Re: Submission Review: 60th Avenue at Box Elder – Infrastructure Site Plan
Application Number: DA-1478-14
Case Numbers: 2024-6039-00

THIRD SUBMISSION REVIEW

BOX ELDER INFRASTRUCTURE SITE PLAN

SITE PLAN 60TH AVENUE

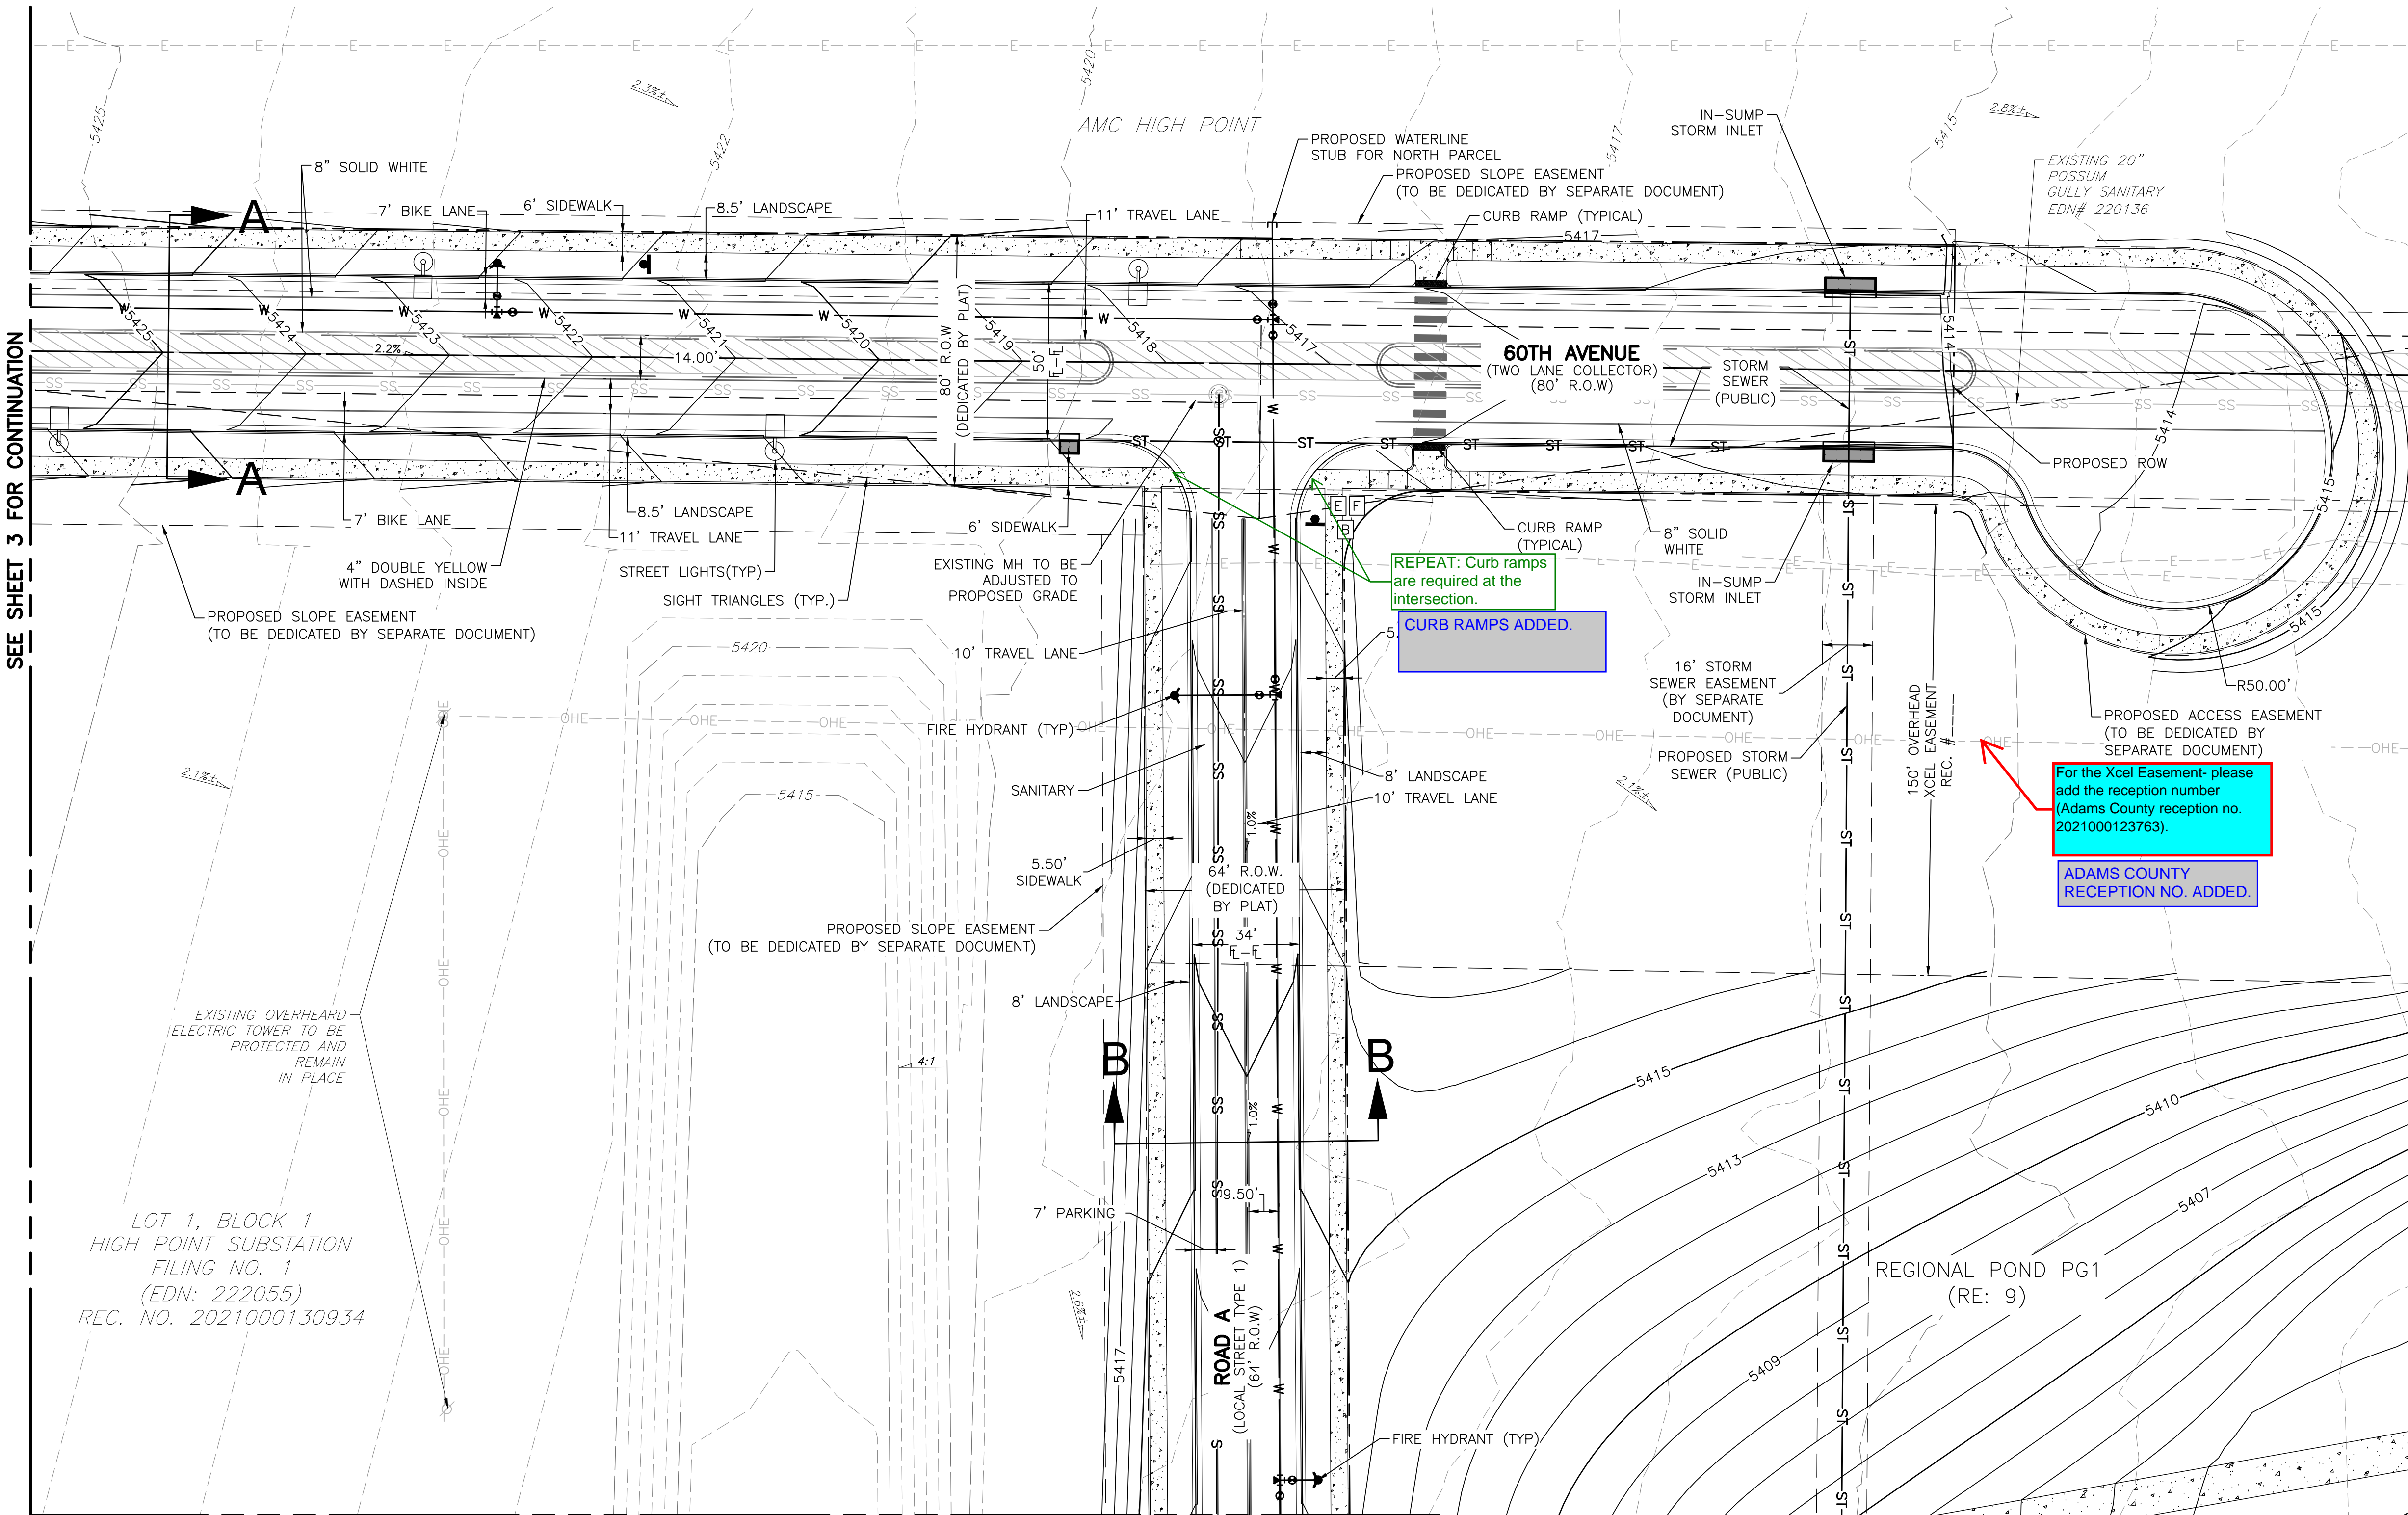
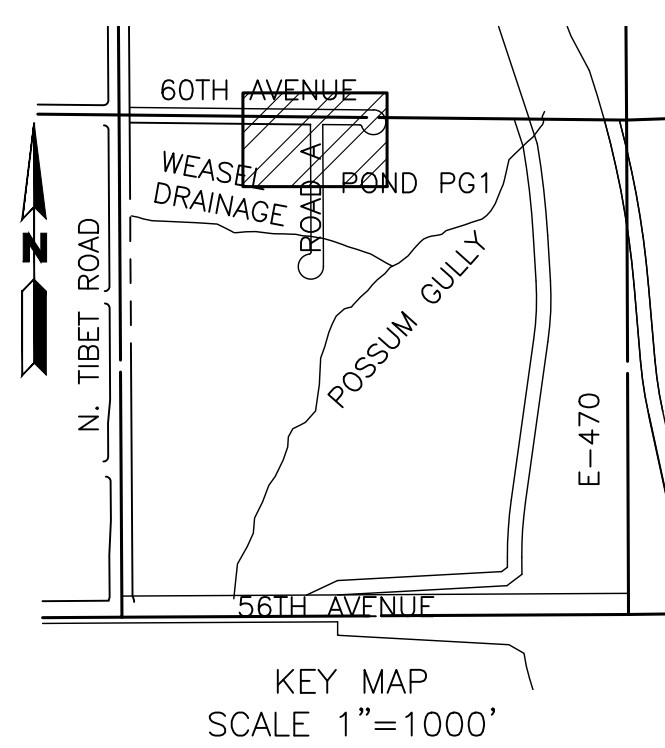
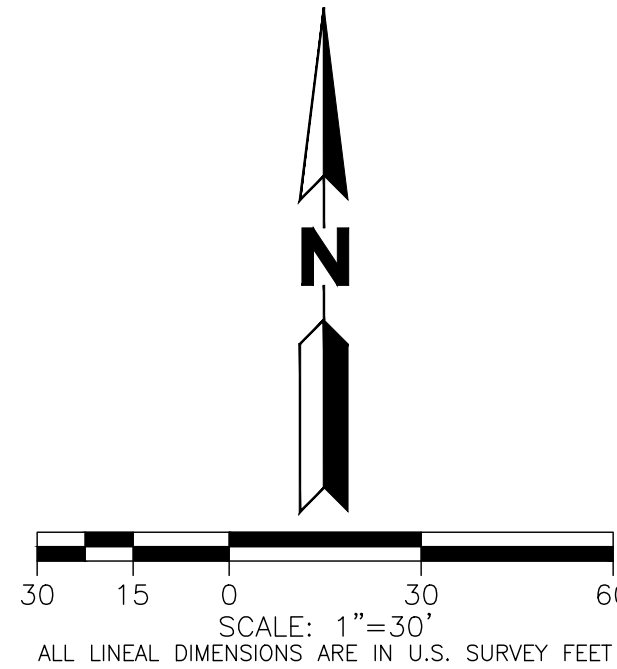
4. **Civil Engineering** (Julie Bingham / jbingham@auroragov.org / Comments in green)
Site Plan
4A. Sheet 4: Comment not addressed: Curb ramps are required at the intersection.

Response: Curb ramps added at intersection.
- 4B. Sheet 6: Add back to the sidewalk to the cul-de-sac.
Response: Back of sidewalk added to cul-de-sac.
5. **Traffic Engineering** (Jason Igo / jigo@auroragov.org / Comments in orange)
Site Plan
5A. Traffic Engineering has reviewed and has no additional comments at this time.

TYPICAL SECTION - WEASEL DRAINAGE

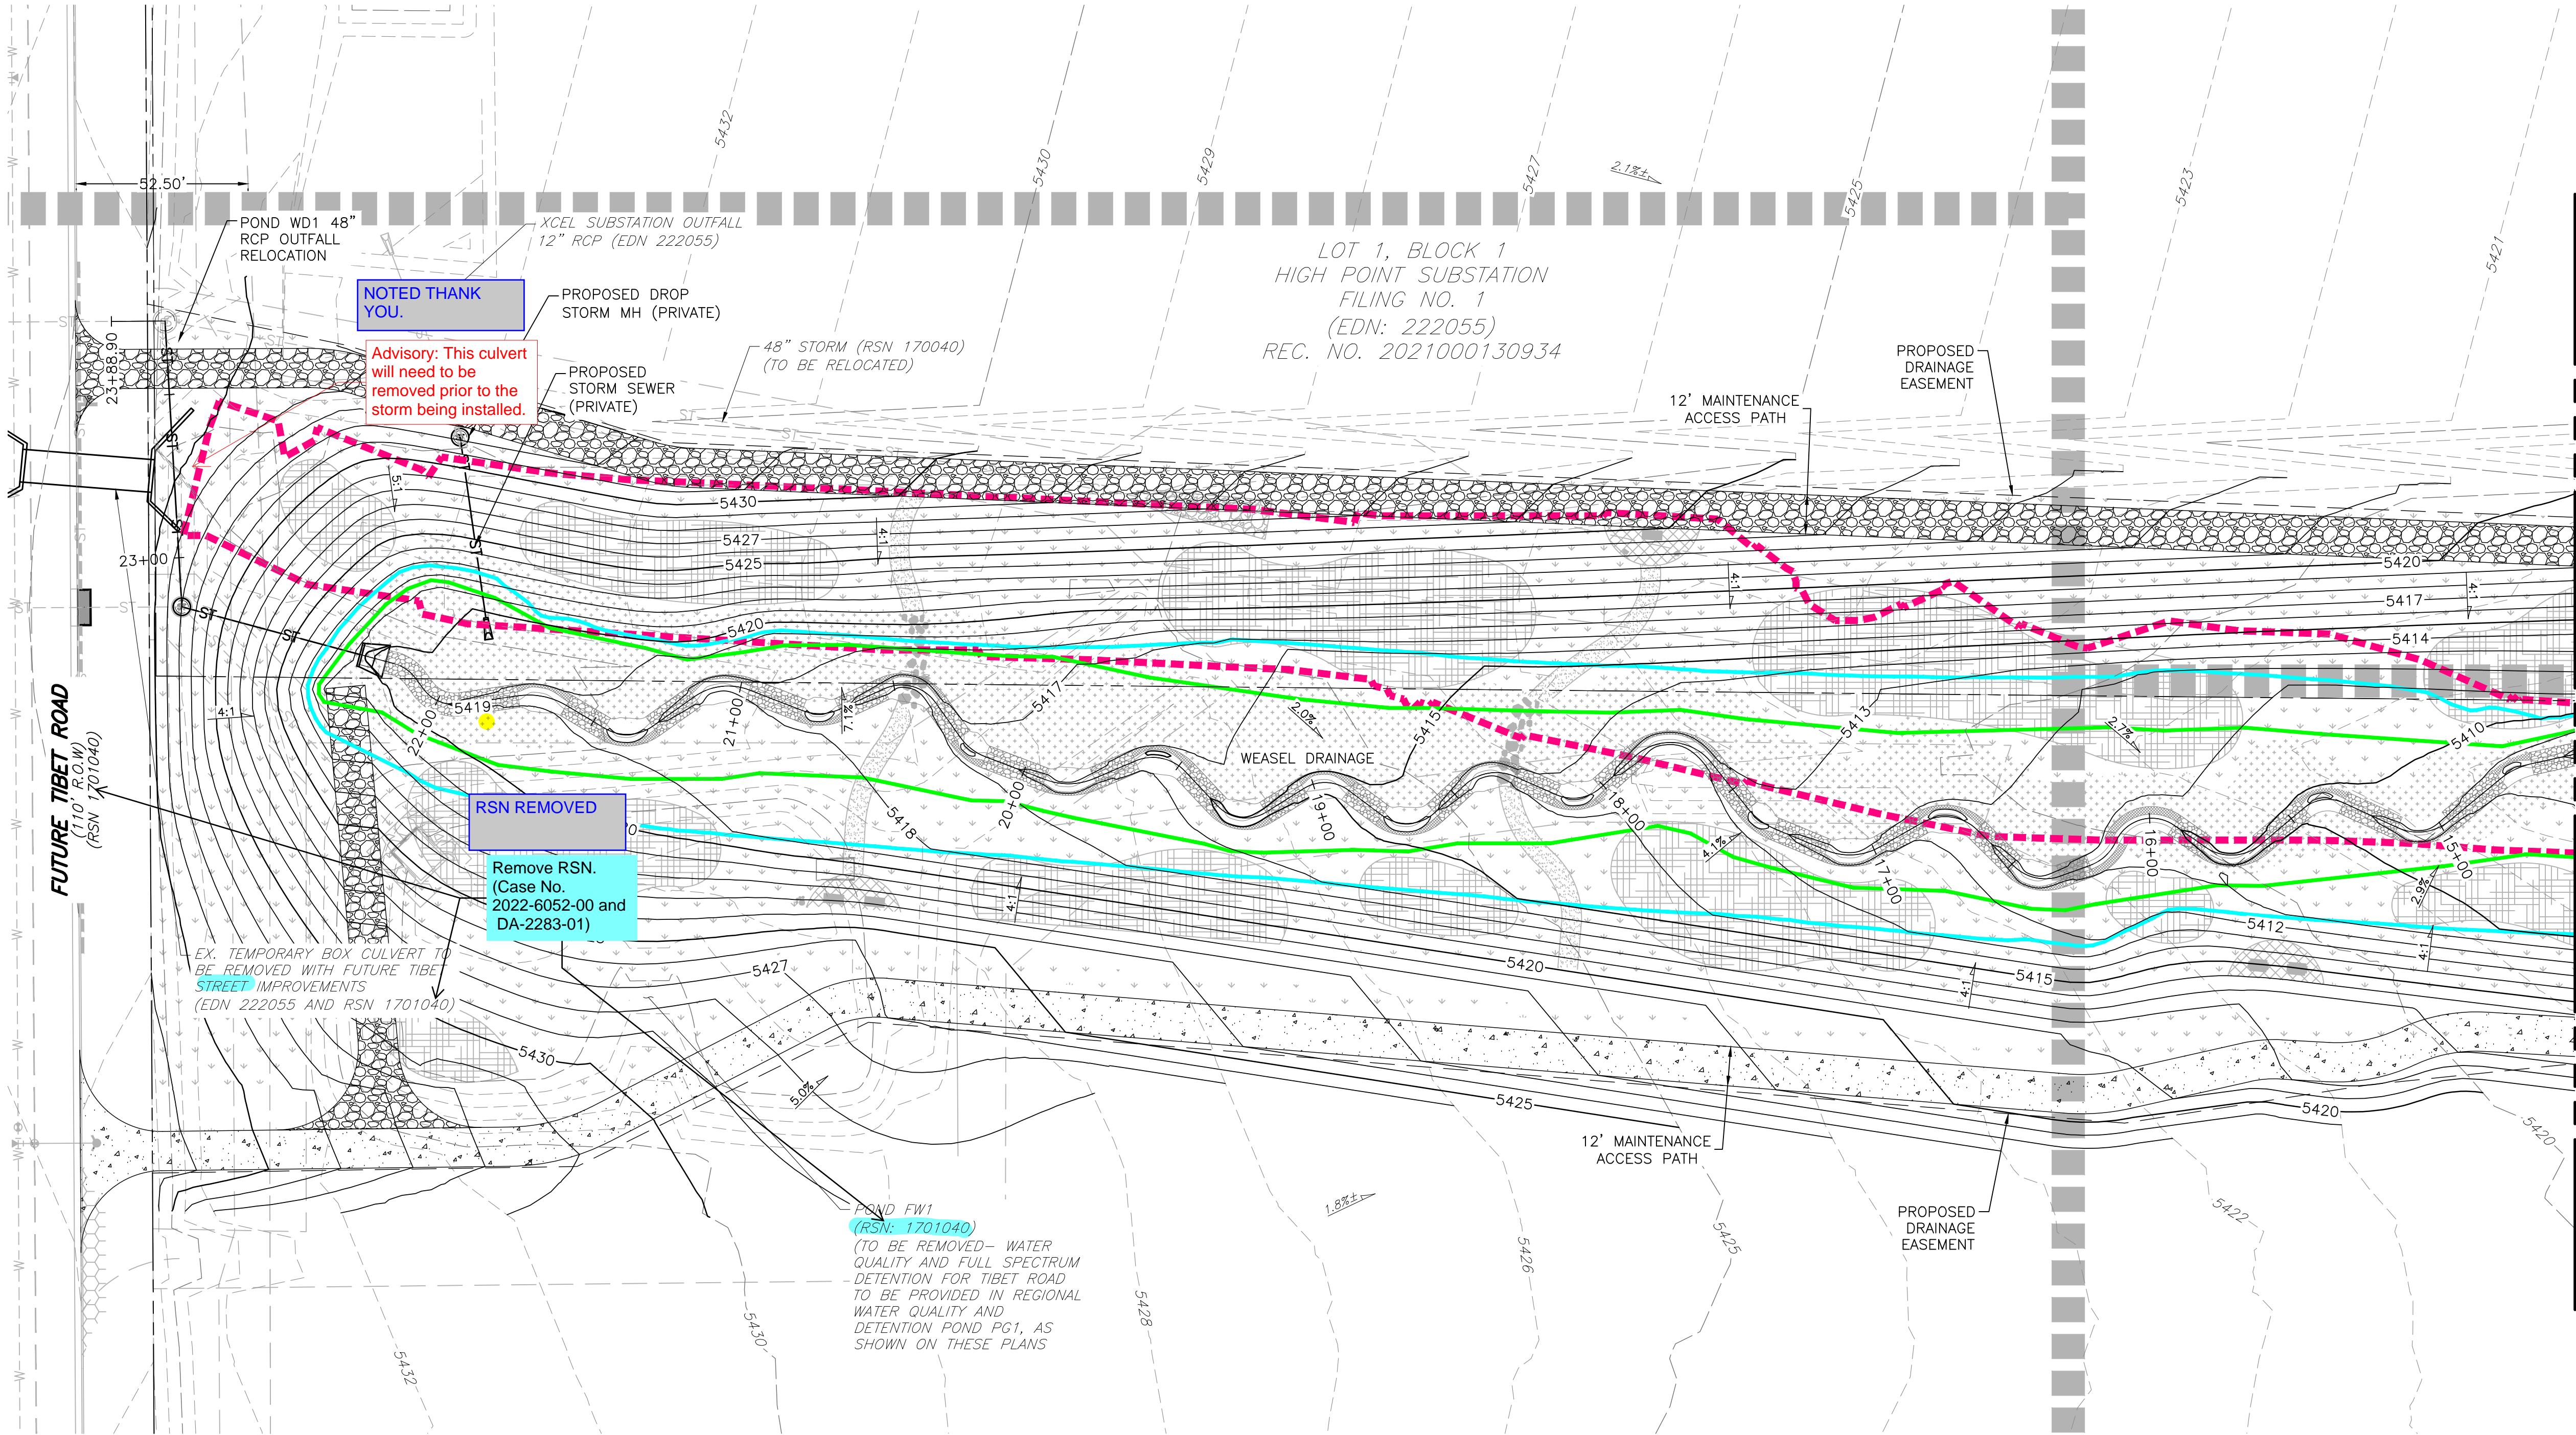
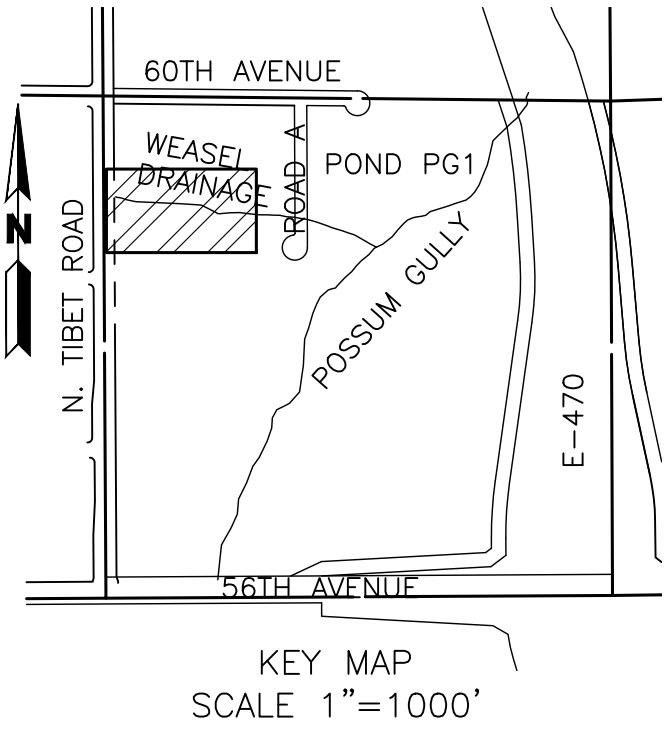
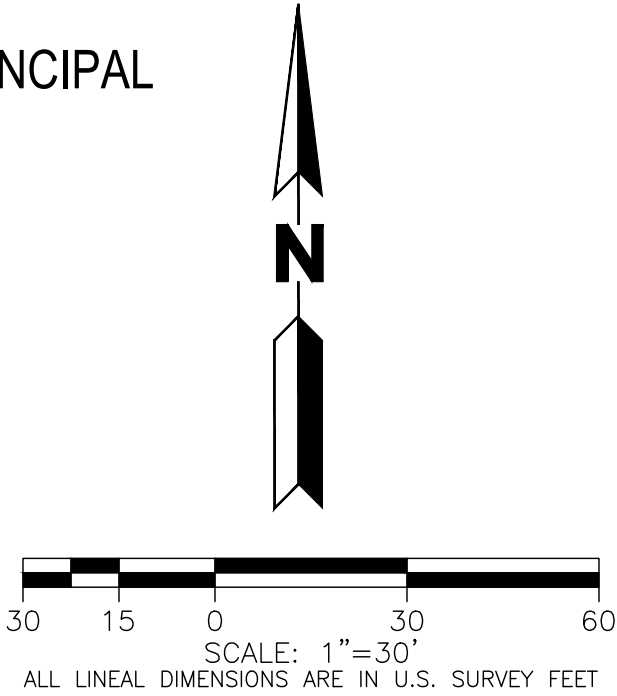
2G. Sheet 5: Revise Tibet "Street" to "Road".

2H. Sheet 5: Remove RSN. (Case No. 2022-6052-00 and DA-2283-01).

Response: Comment acknowledged, thank you.
7. **Aurora Water** (Casey Ballard / 303-7382 / cballard@auroragov.org / Comments in red)
Site Plan:
7A. Sheet 5: Advisory: This culvert will need to be removed prior to the storm being installed.

Response: Tibet Street now 'N. Tibet Road'.

Response: RSN has been removed.

Response: Comment noted, thank you.
8. **Land Development Services – Easements** (Grace Gray / 303-739-7277 / ggray@auroragov.org)
8A. Easement dedication to be submitted to dedicationproperty@auroragov.org, releases to be submitted to releaseeasements@auroragov.org.
